Access Compliance Report

Public Rights-of-Way

Intersection ID: 42360	Main Street: KESTRAL_RIDGE_DR	Cross Street: OSPREY_KNOLL_DR	Location: SW
ADA ID: CA2BEE56107B	Ramp Type: BlendTrans1	Initial Pass/Fail: Fail	Overall Compliance: No
		Severity Score: 8.75

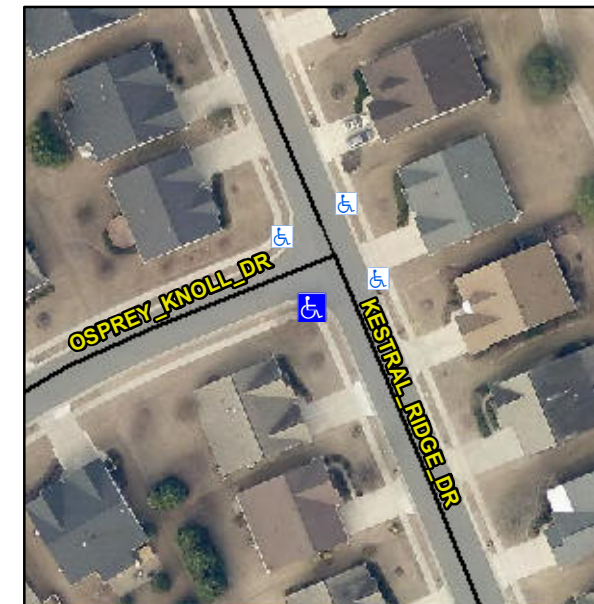
Not Found, R304.5.1

Compliance	Description	Data	Compliance	Description	Data
N/A	Ramp Length (in)	48.0	Yes	BlendTrans Slope (%)	2.0
No	Ramp Width (in)	44.0	Yes	BlendTrans XSlope (%)	0.2
N/A	Flare Type LT	N/A	N/A	Flare Type RT	N/A
N/A	Flare Slope LT (%)	N/A	N/A	Flare Slope RT (%)	N/A
N/A	Flare Traversable LT?	N/A	N/A	Flare Traversable RT?	N/A
N/A	Landing Length (in)	N/A	N/A	DWS Provided?	N/A
N/A	Landing Width (in)	N/A	N/A	DWS Contrast?	N/A
N/A	Landing Slope (%)	N/A	N/A	DWS Length (in)	N/A
N/A	Landing X Slope (%)	N/A	N/A	DWS Full Width?	N/A
N/A	Landing Curb? (Y/N)	N/A	N/A	DWS Offset (in)	N/A
N/A	Shared Landing?	N/A			
N/A	Gutter Ponding?	N/A	N/A	Gutter Slope (%)	N/A
N/A	Gutter Lip Ht (in)	N/A	N/A	Gutter X Slope (%)	N/A
N/A	Painted X Walk1?	No	N/A	Painted X Walk2?	No
	X Walk 1 Direction	To E		X Walk 2 Direction	To N
	X Walk 1 Width (in)	N/A		X Walk 2 Width (in)	N/A
	X Walk 1 Slope (%)	2.3		X Walk 2 Slope (%)	1.0
	X Walk 1 X Slope (%)	1.5		X Walk 2 X Slope (%)	0.9

Remove & Replace Curb Ramp With Two New Directional Ramps or Equivalent.
